**From:** Kathy LaBerge <laborgeonthelake@yahoo.com>  
**Sent:** Friday, June 30, 2017 4:47 PM  
**To:** MN\_COMM\_Pipeline Comments  
**Subject:** Public Comment: Line 3 Project (CN-14-916 and PPL-15-137)

Re: Comments on Draft Environmental Impact Statement  
 General Weakness of the DEIS, Reliance Upon Enbridge Commitments and  
 Statements  
 Proposed Enbridge Line 3 Replacement Project  
 Dockets 14-916 and 15-137

Re: Comments on Draft Environmental Impact Statement  
Serious Detailed Map Set Appendices Issues  
Proposed Enbridge Line 3 Replacement Project  
Dockets 14-916 and 15-137

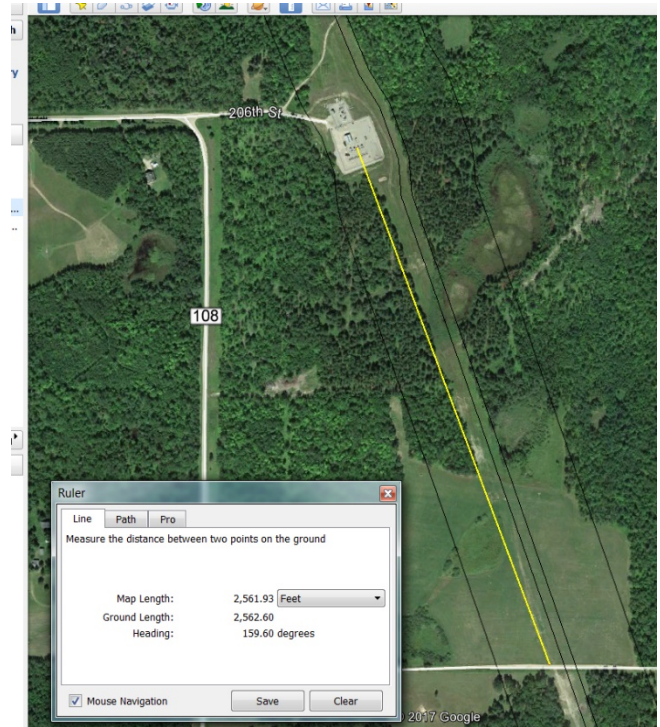
How can the DEIS purport to *“inform the Commission’s decisions by evaluating the potential human and environmental effects of permitting the proposed Line 3 pipeline project, considering reasonable alternatives, and exploring methods for reducing adverse effects”* (page 1-1) if the document can’t tell us how loud the pump stations will be or discuss mitigation for noise-related impacts from pump stations?

The Final EIS must identify pump station noise levels at the source, property boundary, and then incrementally thereafter—with and without mitigation applied. Moreover, the Final EIS should discuss available mitigation to reduce pump station noise above and beyond simply providing an incomplete listing of options (page 6-67). Other options are available, such as vegetation screening with large coniferous trees which would not only reduce noise impacts, but also reduce aesthetic impacts as well.

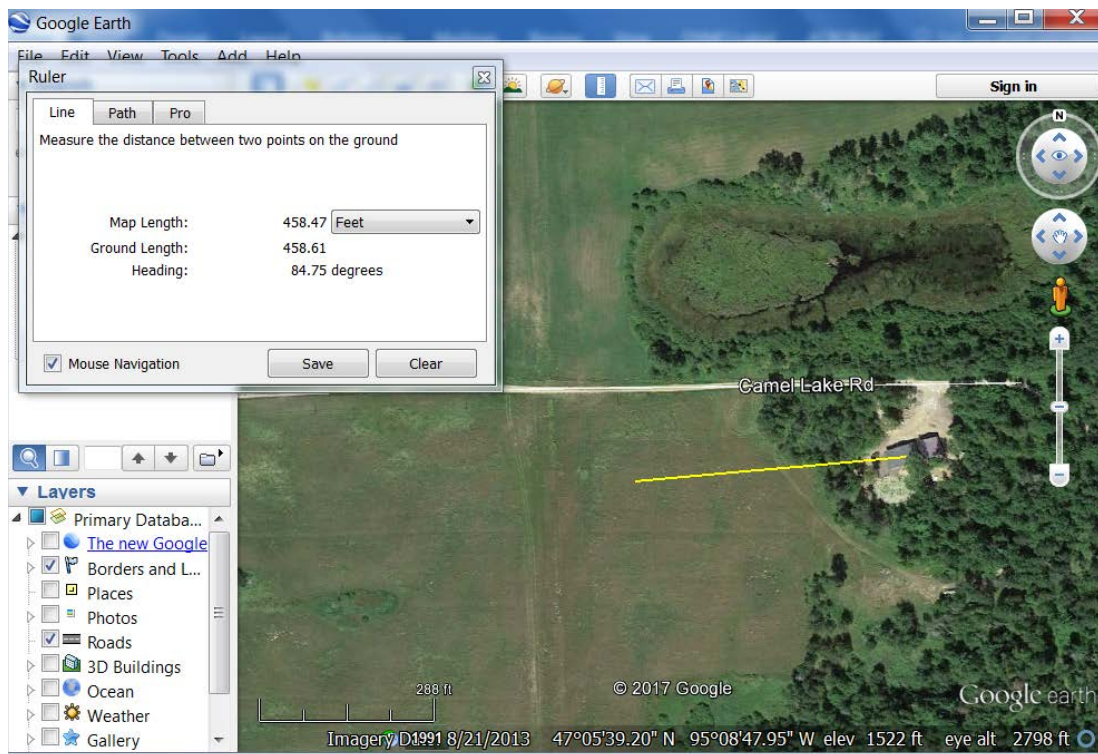
Page 6-63, Table 6.2.2-6. This table indicates the nearest sensitive receptor to the Two Inlets pump station is 1,000 feet away; however, the closest receptor is less than 500 feet from the proposed pump station location. Appendix I from the Scoping EAW indicates a residence at milepost 956.6 approximately 365 feet east of the construction workspace. This home is marked on Map 45a of the detailed map set. This error calls into question the entire analysis pertaining to pump station noise, and further reiterates the need for noise surveys to be made publicly available and results adequately discussed in the Final EIS.

Page 6-86, last paragraph. “The Two Inlets pump station would be within 0.2 mile of two residences, each with a partial view of the permanent structure. For each of these residences, this would be a permanent

Figure ES-3. General Location of Route Alternatives and Route Segment Alternatives

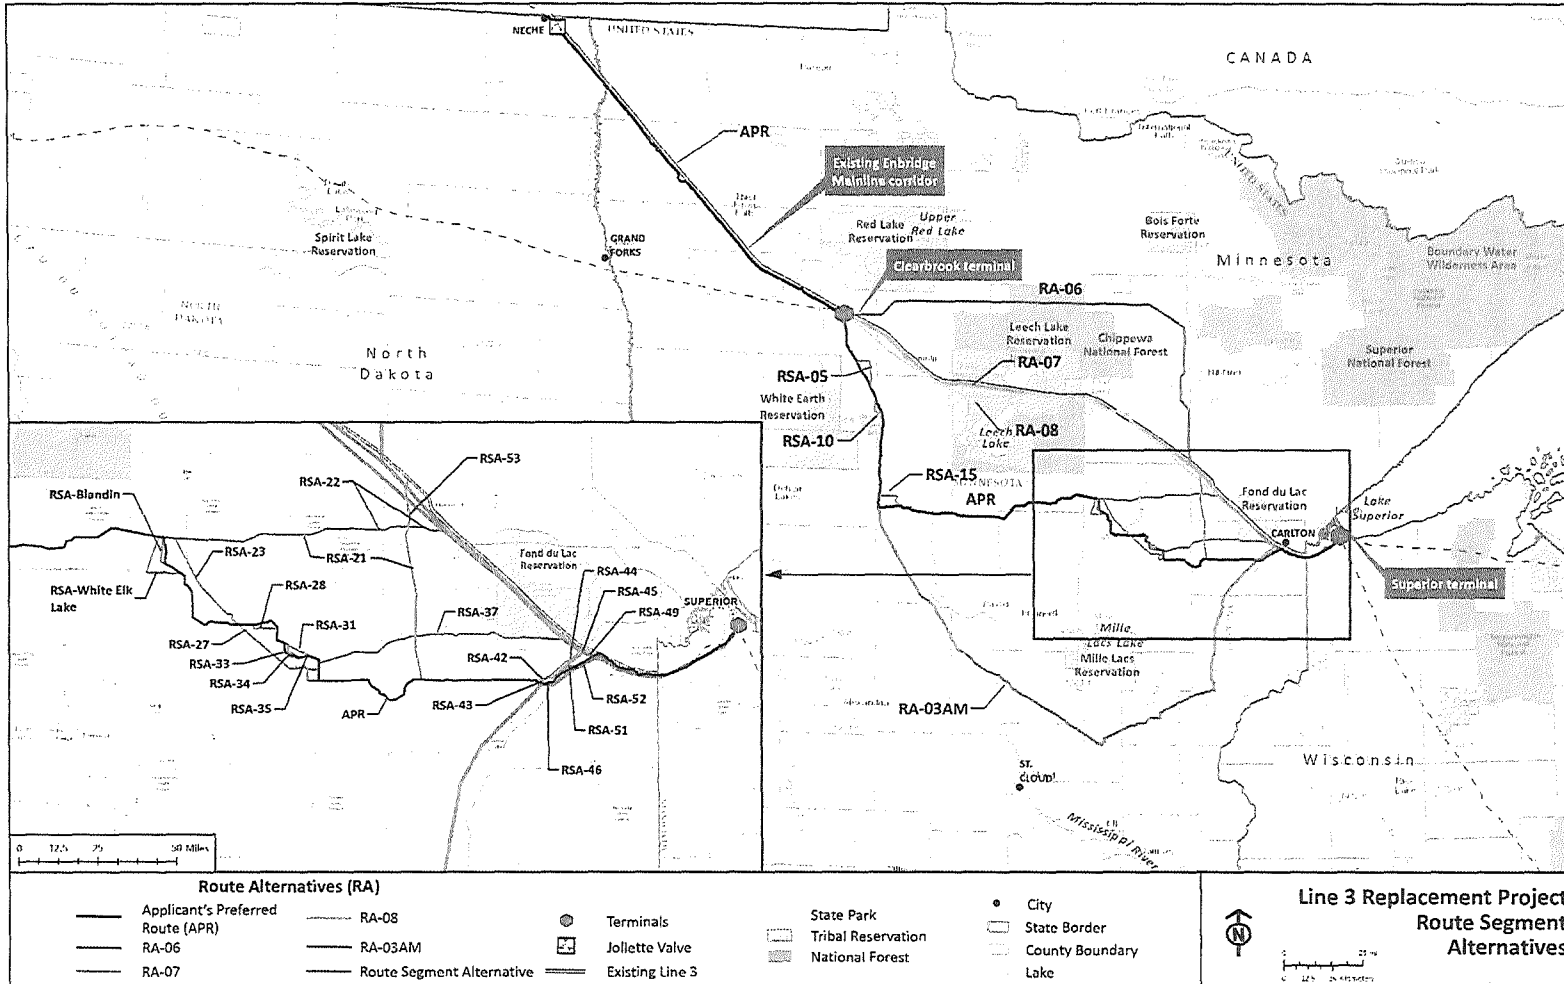
The Long Lake Area Association (Hubbard County) Inc. Board of Directors is very concerned regarding the proximity of the proposed Line 3 Replacement Route Segment Alternative RSA-15 to Long Lake, 29-0161-00, in Hubbard County between Hubbard, MN and Park Rapids, MN. The MN Department of Commerce Figure ES-3 map shows RSA-15 being very close to Long Lake and Chapter 7 pg 14, figure 7.3-3 (see attached). The DOC description of RSA-15 does not mention Long Lake which has 500 unique lakeshore parcel owners based on 2013 Hubbard County GIS and Assessor information on Long Lake below. The south end of the lake is in the town of Hubbard MN also. Therefore, we request that the MN Department of Commerce, the MPCA and MN DNR working together through the Memo of Understanding be cognizant of, document in the EIS and consider the sensitive and valuable resource that Long Lake is as route segment alternatives are compared and spill scenarios are analyzed.

Attachment: MN DOC Fig ES-3 map shows RSA-15 being very close to Long Lake & Chapter 7 pg 14, fig 7.3-3
